**RE: MCPHILLAMYS GOLD PROJECT SSD 9505 – RESPONSE TO ADDITIONAL MATERIAL**

**McPhillamys Gold Project – Noise & Vibration Peer Review by RCA Australia,  
Technical Response**

Re: Response to submissions from EDO third-party reviewer comments on groundwater related aspects for the IPC

Figure 1  
 Weather Station Locations  
 MAC170434  
 McPhillamys Gold Project  
 Mine Development

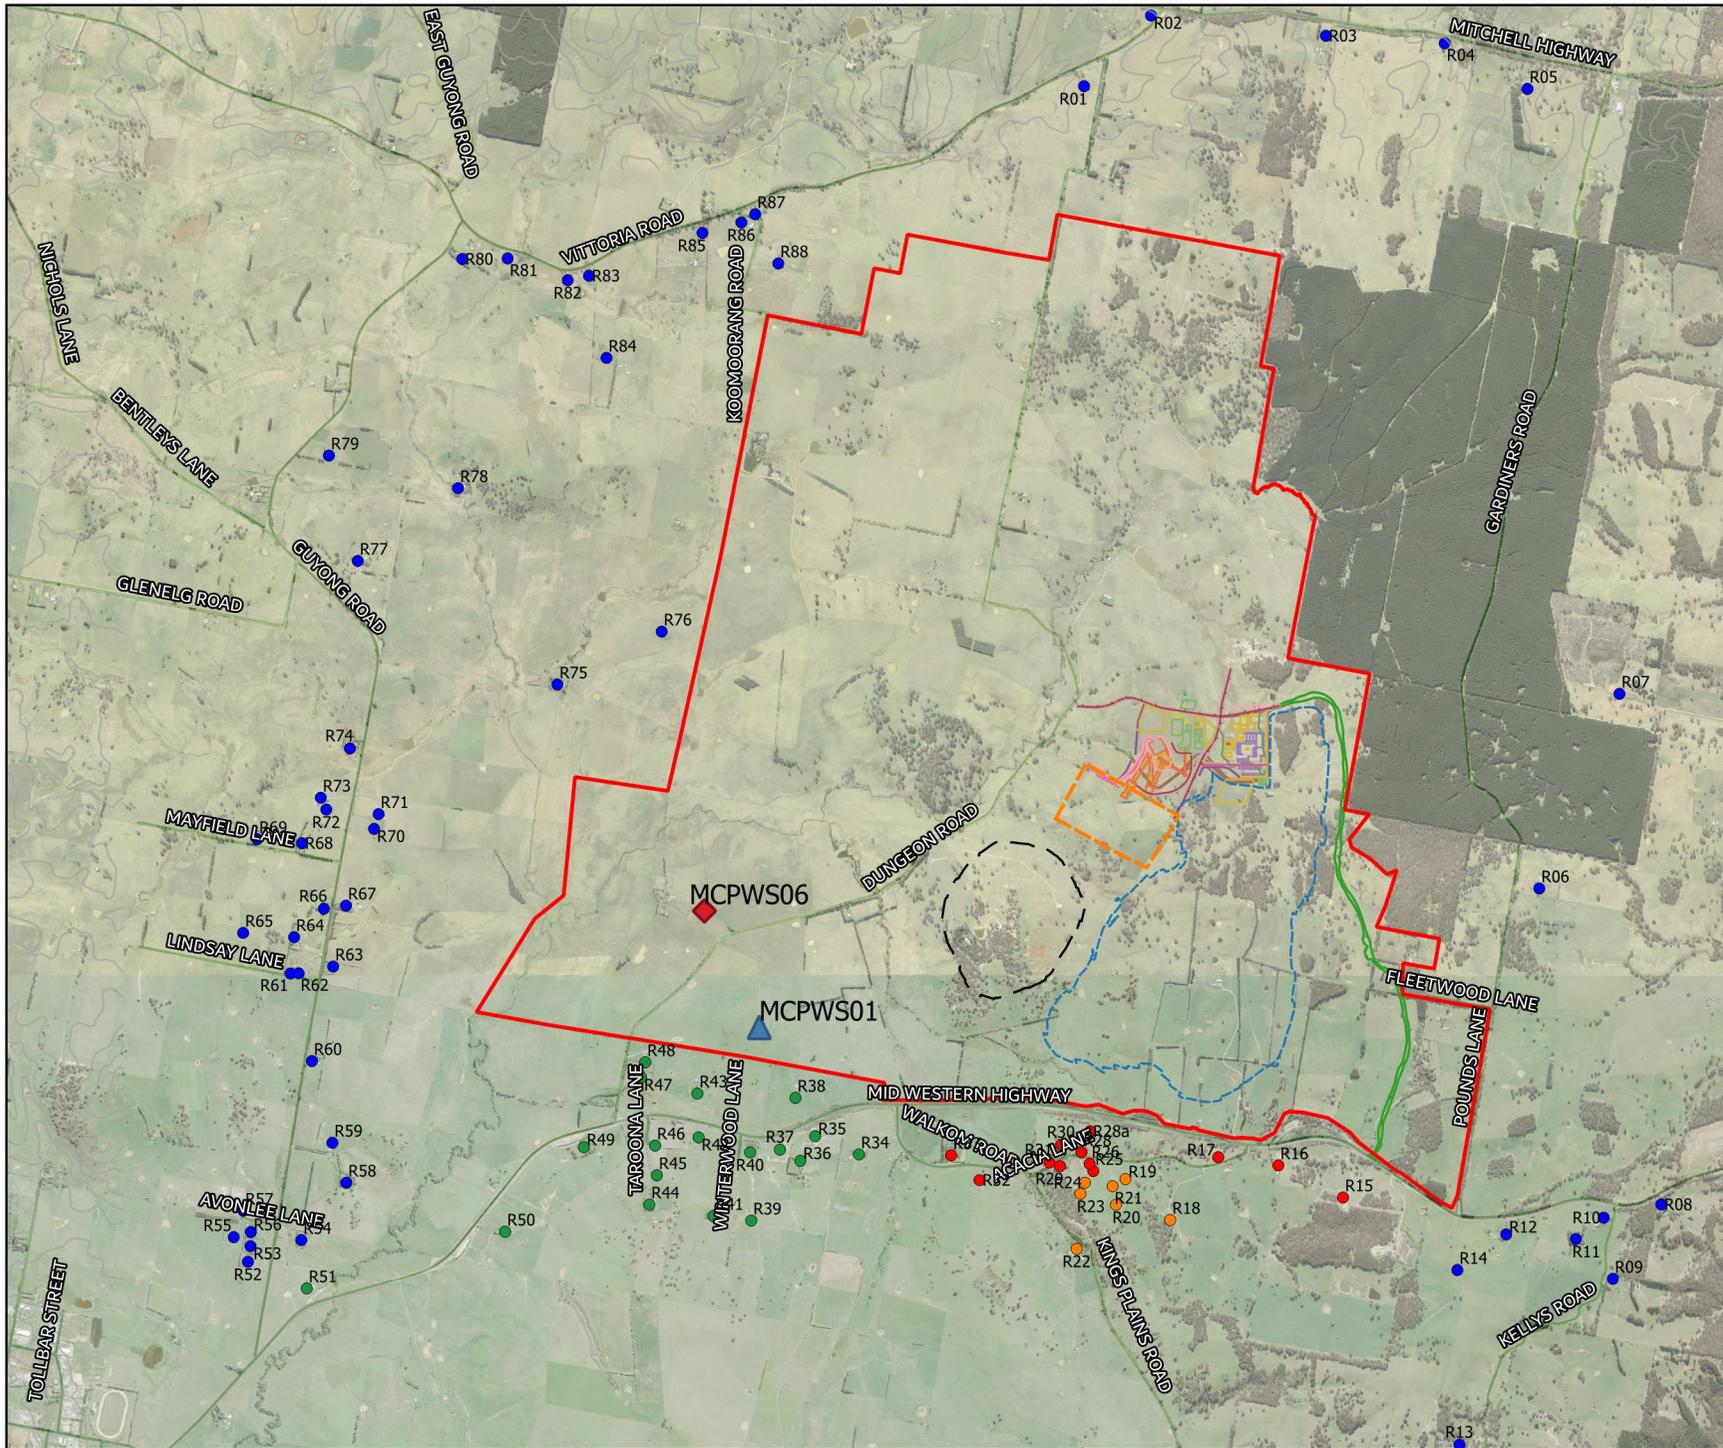
**RCA Comment** - “*RCA recommend that the presence of noise enhancing weather be reviewed against a second nearby weather station to double check this vital assessment factor.*”

**RCA Comment** - *“Section 5.2 of the ANVIA states that the Construction Noise Strategy (Transport for NSW, 2018) sets a safe working distance of 25 m from a large vibratory roller to achieve the residential human response criteria for continuous vibration, and that since the closest receiver to construction activities is greater than 25 m, no vibration impacts are anticipated. RCA believe this is a typographical error. The Construction Noise Strategy sets a safe working distance of 25 m for a large vibratory roller (> 18t) to avoid cosmetic damage to residential buildings, but sets a 100 m safe working distance for the same plant to avoid human comfort vibration impacts. We understand that the closest receiver to the proposed intersection may be within 100 m, and human comfort vibration impacts may therefore be experienced. The ANVIA should be updated for accuracy.”*

**MAC Response** - MAC has completed an analysis of weather data from the Orange Airport BOM weather station (23km from the project site) which shows a similar trend to that analysed for the ANVIA in that calm wind conditions occur approximately 7% of the time annually (data to determine the occurrence of temperature inversions was not available). Such an analysis could have been conducted by RCA, to address this question. The subsequent MAC analysis of readily available data demonstrates that this is of no consequence and should be considered as a minor point that will not alter the outcome/conclusion of the ANVIA.

The weather station at Kings Plains has been decommissioned and replaced by a new station – MCPWS06 (refer **Figure 1**). Analysis of the data from MCPWS06 from April 2022 to February 2023 shows a similar trend in that calm wind conditions occur approximately 5% of the time annually indicating the high occurrence/presence of windy conditions. Analysis of the winter 2022 (June-August) data from MCPW06 also indicates the occurrence of F and G Class temperature inversions occur for <17% of the time and hence are not a feature of the area and not relevant to the assessment.

The review incorrectly states that the “closest receiver to the proposed intersection may be within 100m”. The closest receiver is 130m (refer **Figure 1**) from the proposed intersection. Hence, potential vibration levels would satisfy the requirements for human comfort.
